Agenda Item #: 3 SUB-002745-2023

Cross Pond Subdivision, First Addition, Resubdivision of Lot 2

- Subdivision approval to create two (2) legal lots of record from one (1) existing legal lot of record.

SITE PLAN

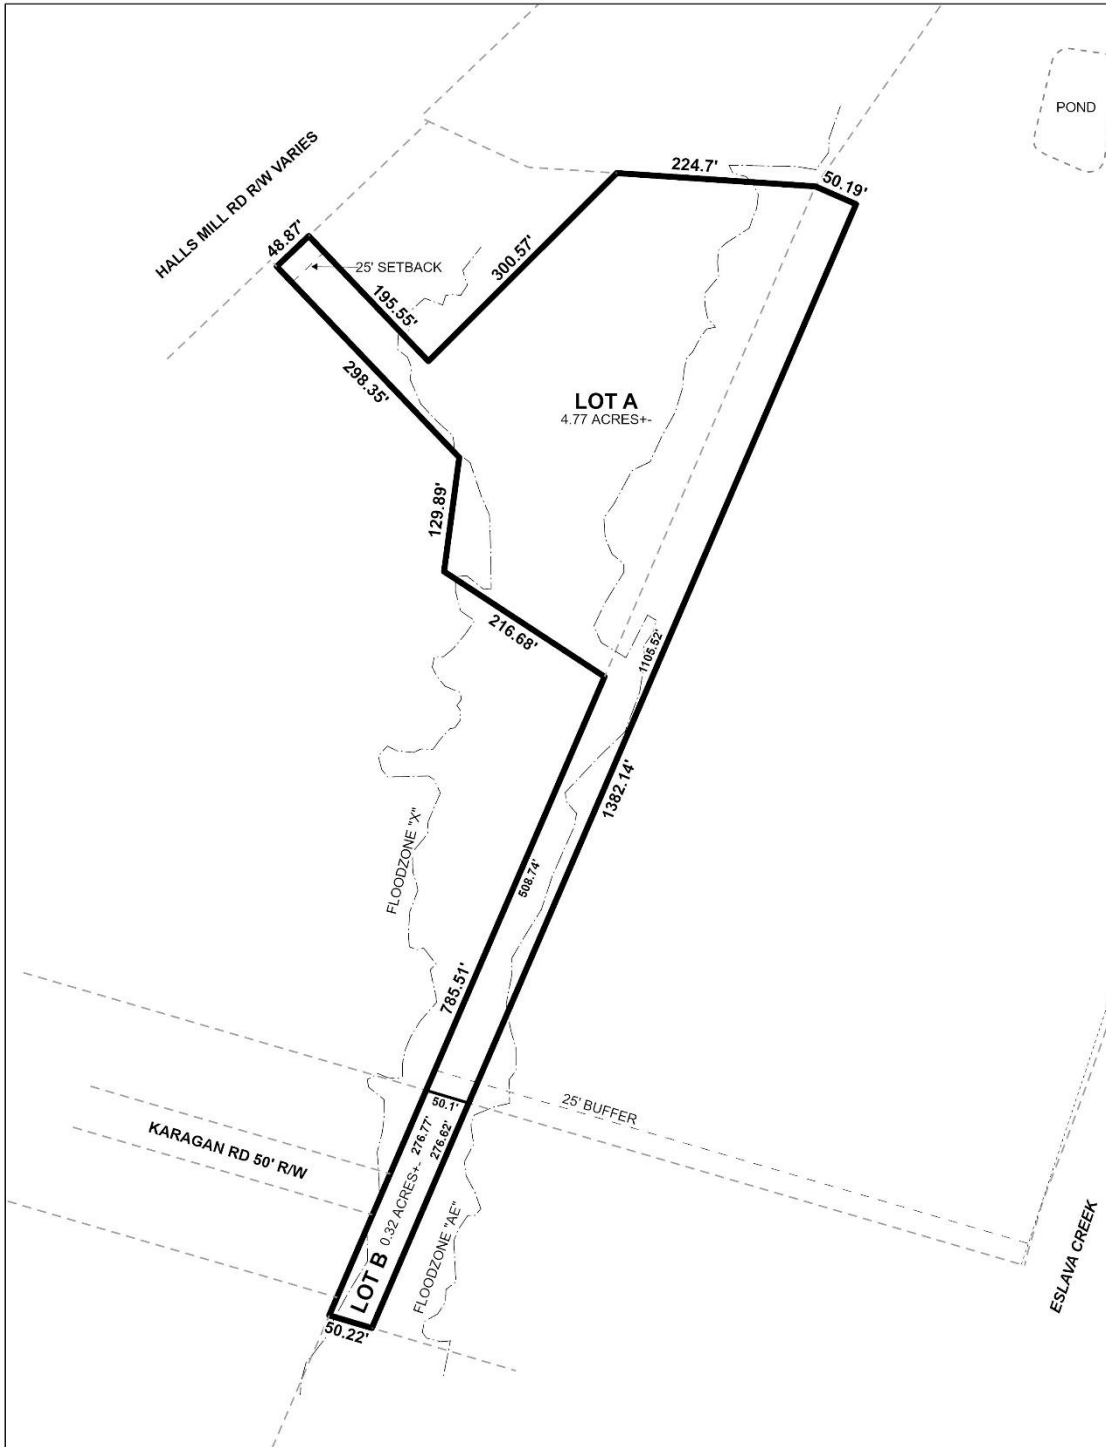
Proposed Lot B would have frontage at the East terminus of Karagan Drive, and proposed Lot A would have frontage along Halls Mill Road. Dedication was provided with the recording of Cross Pond Subdivision, First Addition, to provide 50 feet from the centerline of Halls Mill Road; therefore, no further dedication would be required.

The plat should be revised to illustrate a 25-foot minimum building setback line on Lot B as blocked-out from the East terminus of Karagan Drive. A 25-foot minimum building setback line is illustrated on Lot A within the 50-foot wide "pole" as measured from the Halls Mill Road right-of-way. The plat should be revised to illustrate the 25-foot minimum building setback line for Lot A as blocked-out from where the lot is at least 60 feet wide.

Most of Lot A would follow the same irregular shape as Lot 2, Cross Pond Subdivision, First Addition, a "flag lot." Per Section 6.C.9. of the Subdivision Regulations, flag-shaped lots are generally not allowed; therefore, a waiver of Section 6.C.9. of the Subdivision Regulations would be required for approval, and would seem in order.

The 50±-foot width of Lot B is substandard. Section 6.C.(b) of the Subdivision Regulations requires residential lots within the suburban sub-district to be at least 60-feet wide. Lot B also exceeds the width-to-depth ratio of Section

6.C.3. of the Subdivision Regulations. As such, waivers of Section 6.C.(b) and 6.C.3. of the Subdivision Regulations would be required for approval.

Lot A contains a recorded 25-foot buffer strip at its South end, and this should be retained on the Final Plat, if approved.

1. Revision of the Final Plat to illustrate a 25-foot minimum building setback line on Lot B as blocked-out from the East terminus of Karagan Drive;
2. Revision of the Final Plat to illustrate the 25-foot minimum building setback line for Lot A as blocked-out from where the lot is at least 60 feet wide;

3. Provision of a note on the Final Plat stating that Lot A cannot be further resubdivided until such time that direct access to a compliant, fully improved roadway can be provided;

4. Retention of the lot size labels in both square feet and acres on the Final Plat, or the furnishing of a table on the Final Plat providing the same information;

5. Retention of the recorded 25-foot buffer strip at the South end of Lot A on the Final Plat;
6. Compliance with all Engineering comments noted in this staff report;
